**PROPOSED RESIDENTIAL DEVELOPMENT
LAND EAST OF BEDFORD ROAD, LOWER STONDON
(NORTH HERTFORDSHIRE LOCAL PLAN SITE LS1)**

ASSESSMENT OF LOCAL TRANSPORT IMPLICATIONS

C M VEASEY CMILT MCIHT

November 2017

Screenshots of Two TRICS Data Areas Used and LS1 Area

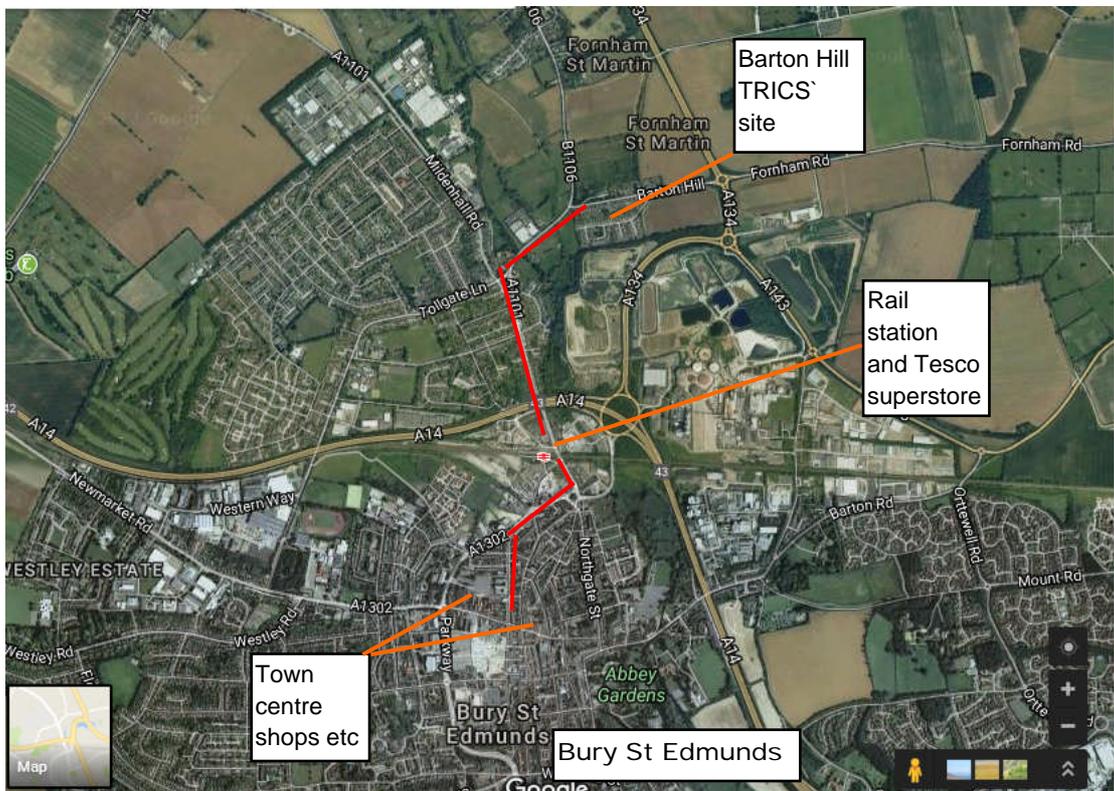
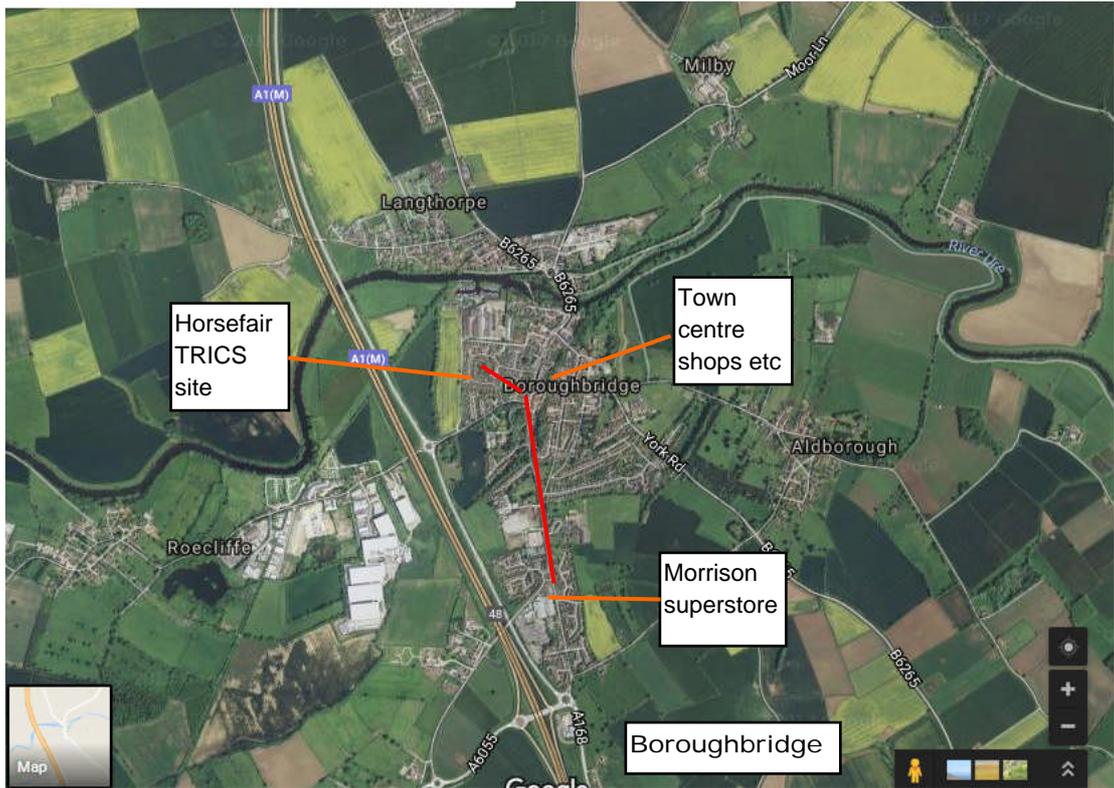
- 8.4 Aerial view screenshots of the Boroughbridge, and Bury St Edmunds areas highlighting the two TRICS sites and their access routes to key facilities, and the comparative screenshot for the Henlow Camp/ Stondon area highlighting the LS1 development site, are reproduced at a common scale at Appendix B of this report.

- 8.5 These two TRICS sites are thus not reasonable comparators for the much less favourably located LS1 site, and the car trip rates derived from them, which have then been used in the developer's TA to estimate the motor traffic the development would generate, are likely to be significant underestimates – residents of the Boroughbridge and Bury St Edmunds developments are far less likely to need or wish to drive for many purposes than residents of the
